**RELEASED FOR  
 FABRICATION / INSTALLATION**  
 PPPL Drafting:

Oak Ridge National Laboratory managed for the DEPARTMENT OF ENERGY under U.S. GOVERNMENT contract DE-AC05-00OR22725 UT-BATTELLE, LLC, Oak Ridge, Tennessee PROJECT NAME						
NATIONAL COMPACT STELLERATOR EXPERIMENT VACUUM VESSEL PERIOD INSPECTION AND LEAK CHECK ASSEMBLY						
VERSION NO.	PLANT	BLDG	FL	SHT OF	TYPE	CLASS
5	X-10	5700	3	2 19	A	U
RELEASE LEVEL		SE120-004			REV	
Fabrication					2

TYPICAL PORT 15A AND 15B  
SECTION PORT15-PORT15

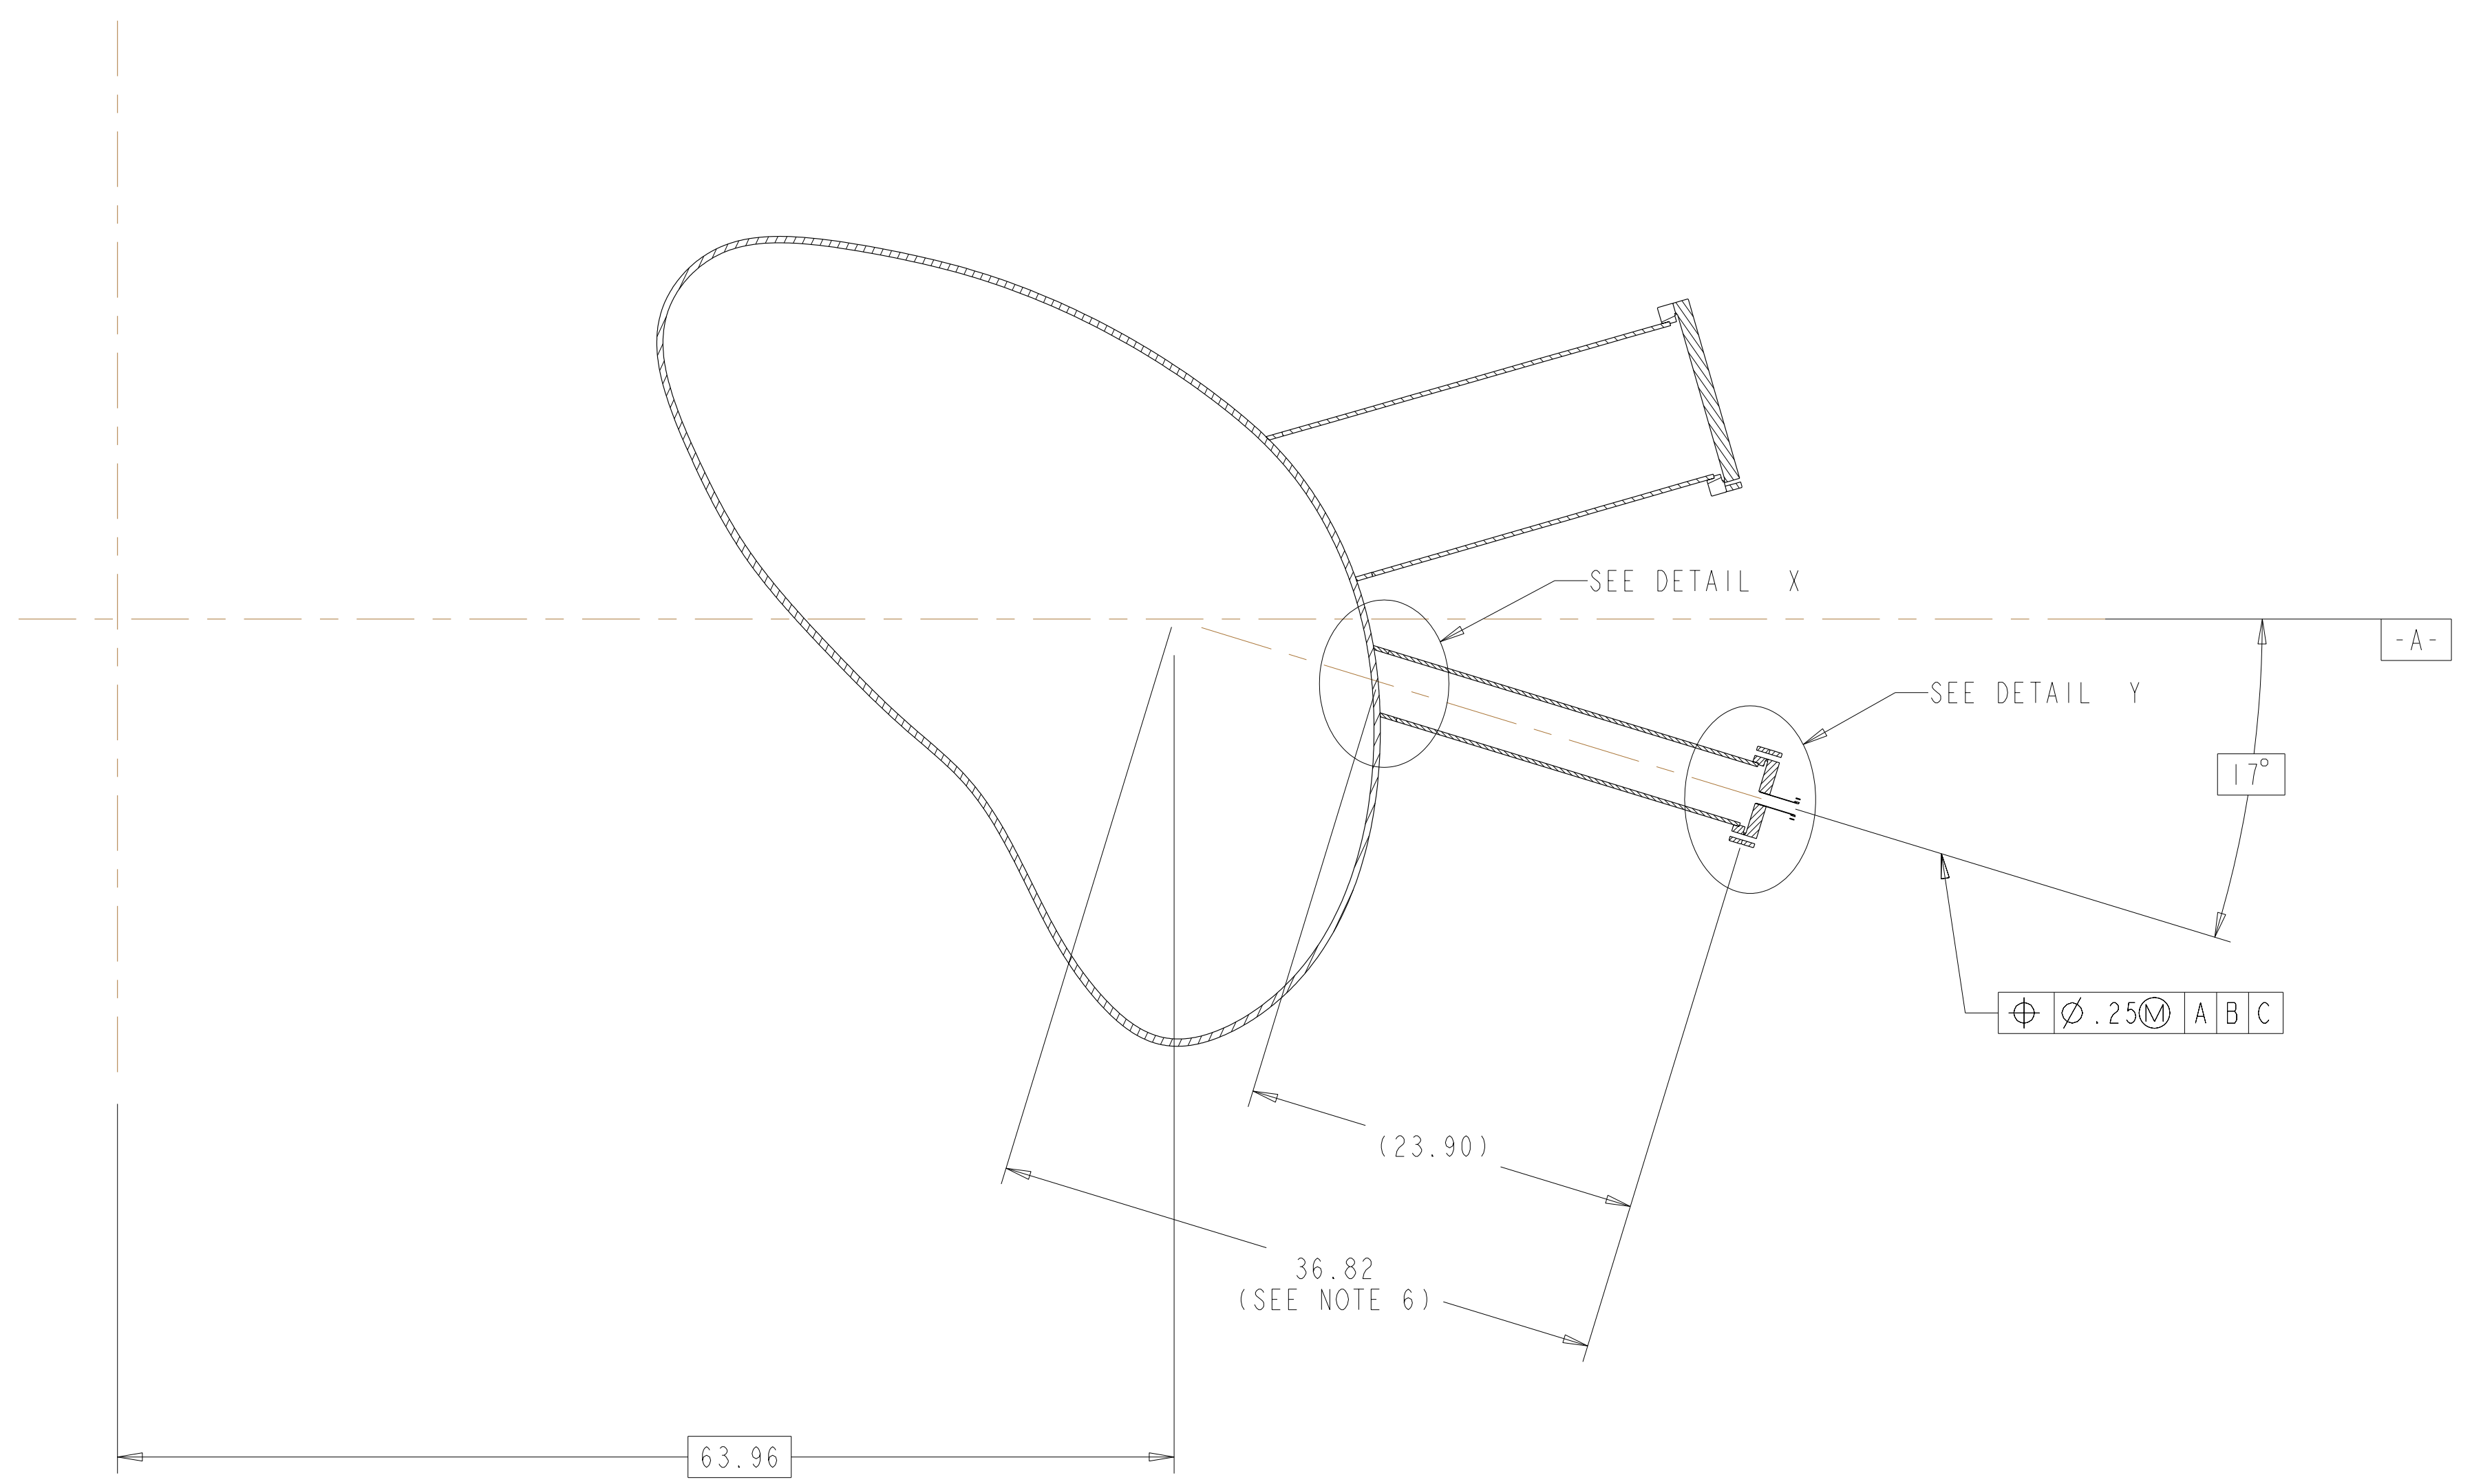
**Rev 2-e: ECN-5021 (RFD-12-017) approved alternate methods for welding the port extensions to the VVSA (See ECN-5021 for details). - Only applicable to VVSA #3 - VVSA #1 and #2 covered by NCR 19464.**

**ECN-5082.** Requirement originally included grooves to facilitate leak checking by vendor. However, vendor elected another means of leak checking and therefore the grooves are no longer required. Specifically, this ECN eliminated the leak checking groove on SE121-014 (Rev 1-c) and SE1221-091 (Rev 0-a). Additionally, this ECN added a missing weld symbol to SE121-004 (Sheets 4 through 19) for joining the port extensions to the vessel (Rev 2-d).  
**(See ECN-5082 for details)**

SECTION PORTNB-PORTNB

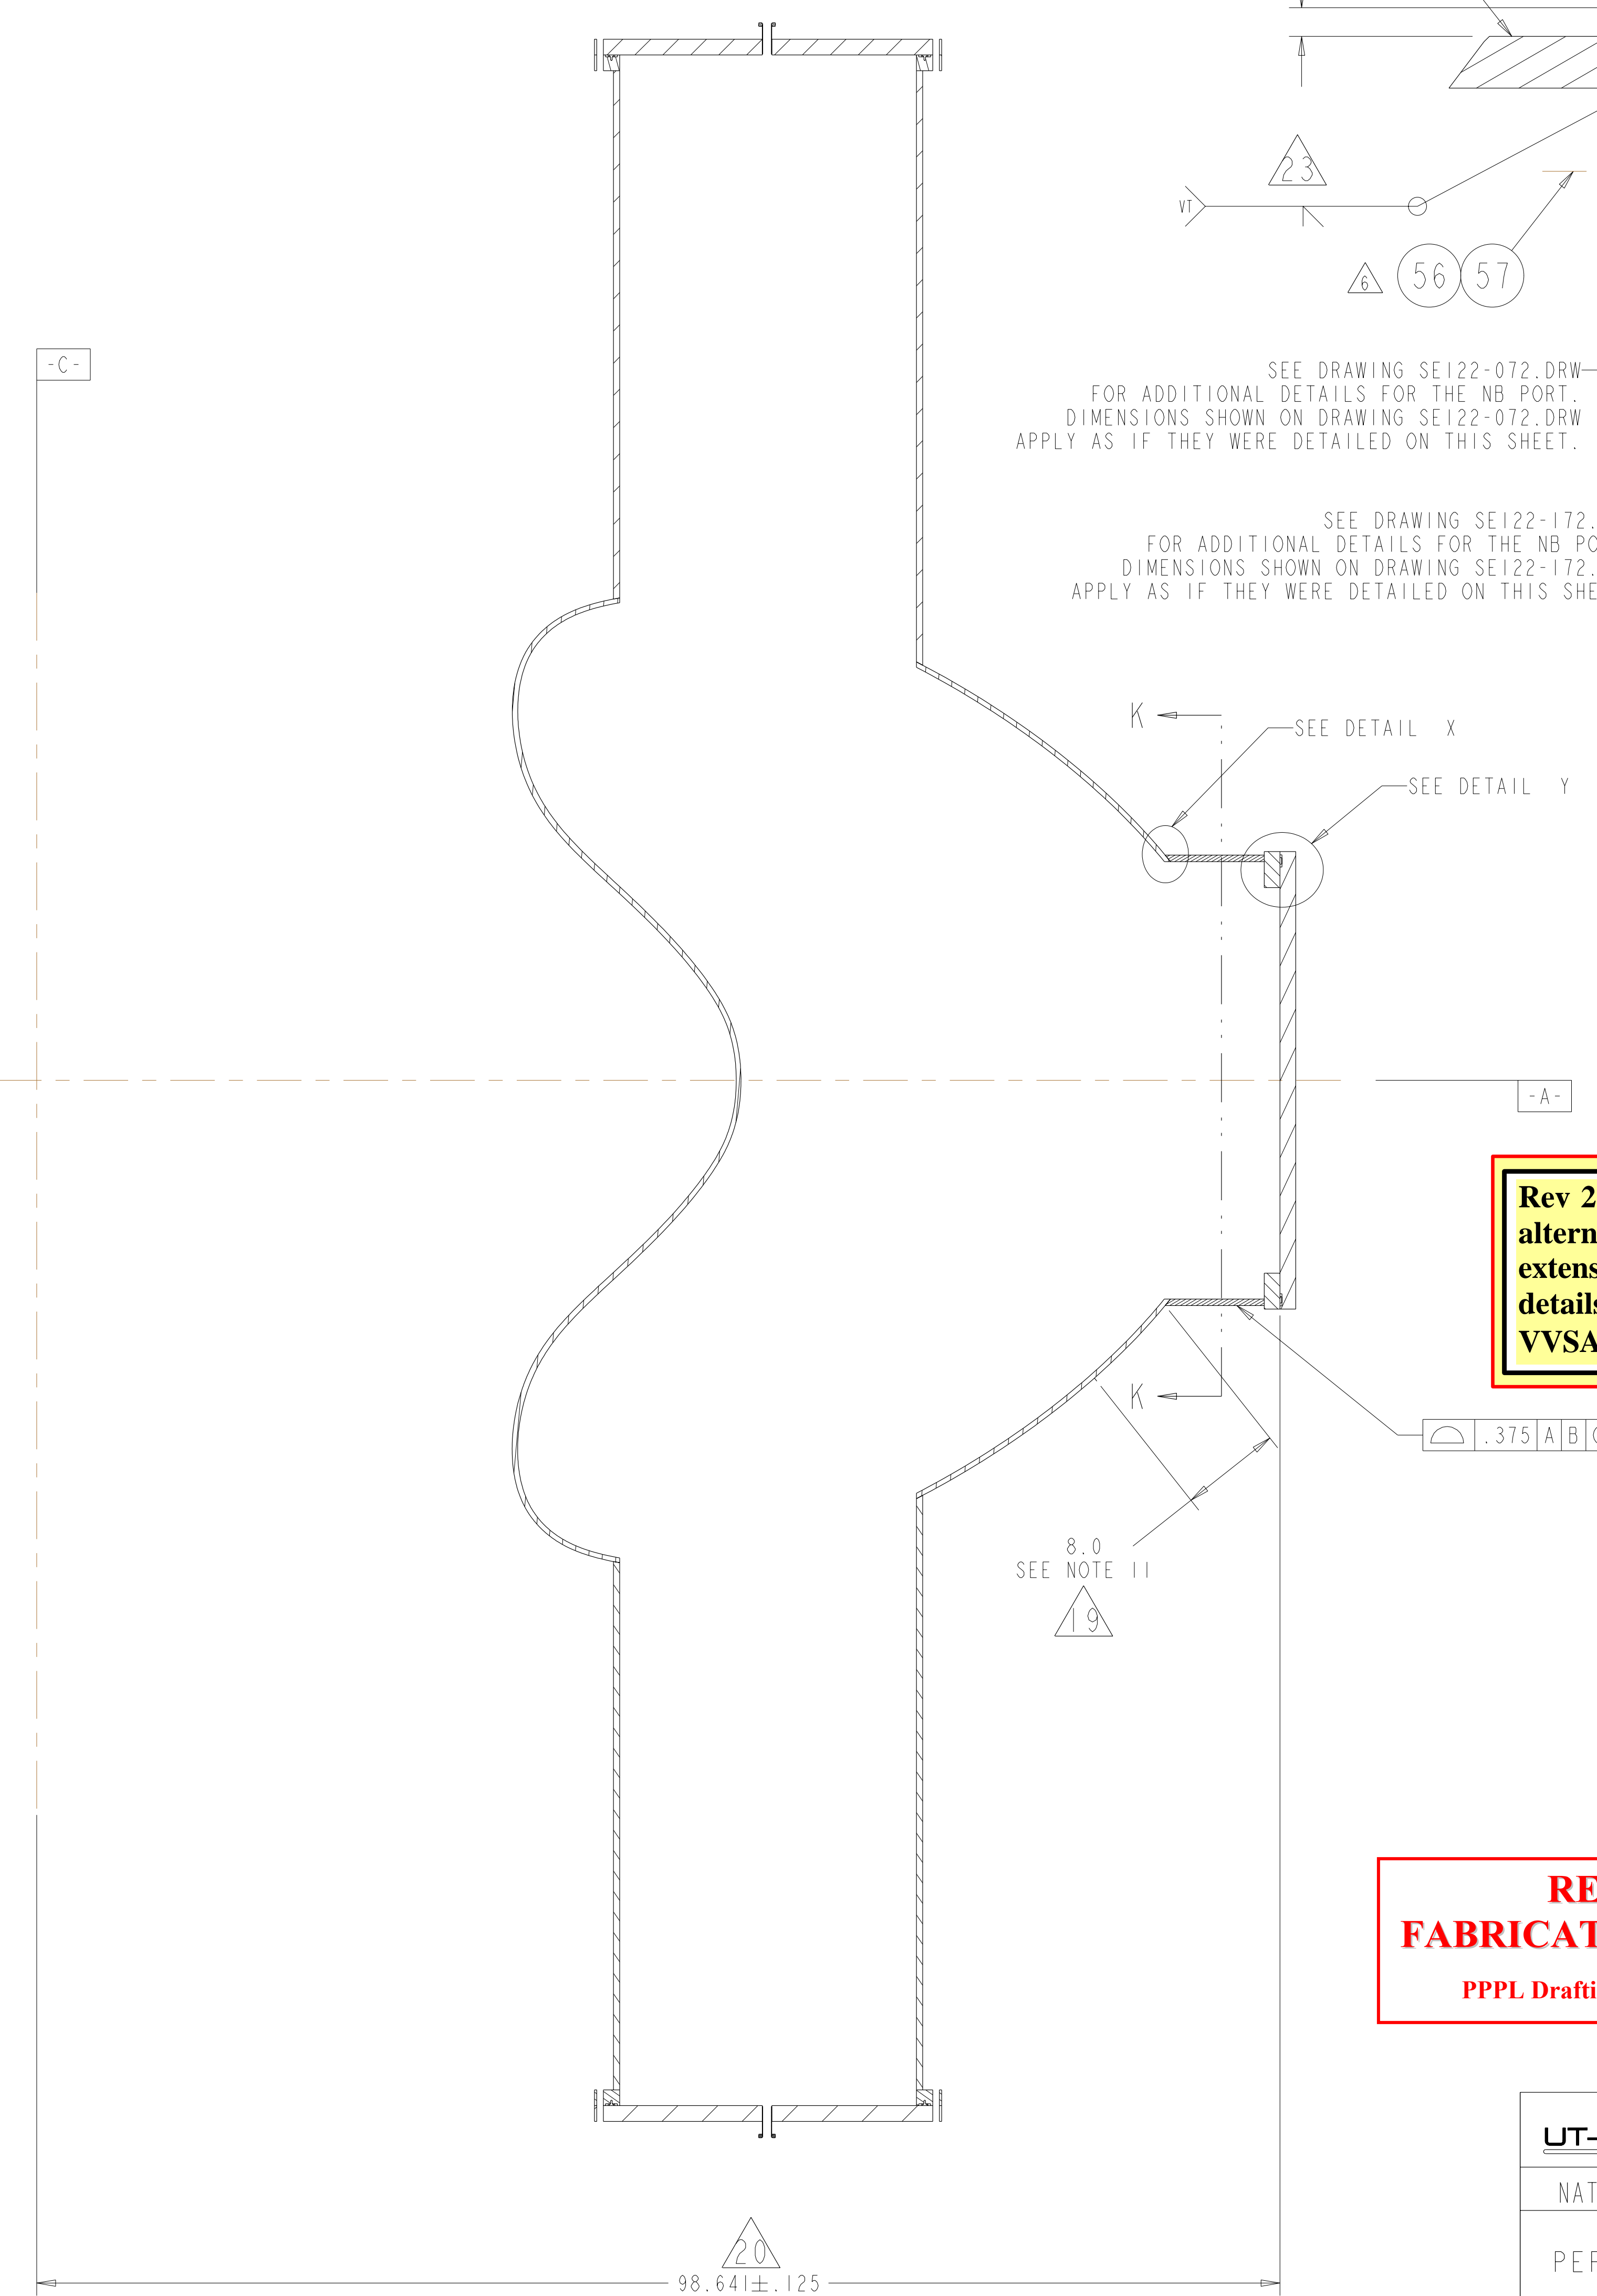
**ECN-5082.** Requirement originally included grooves to facilitate leak checking by vendor. However, vendor elected another means of leak checking and therefore the grooves are no longer required. Specifically, this ECN eliminated the leak checking groove on SE121-014 (Rev 1-c) and SE1221-091 (Rev 0-a). Additionally, this ECN added a missing weld symbol to SE121-004 (Sheets 4 through 19) for joining the port extensions to the vessel (Rev 2-d).  
 (See ECN-5082 for details)

**Rev 2-e: ECN-5021 (RFD-12-017) approved alternate methods for welding the port extensions to the VVSA (See ECN-5021 for details). - Only applicable to VVSA #3 - VVSA #1 and #2 covered by NCR 19464.**
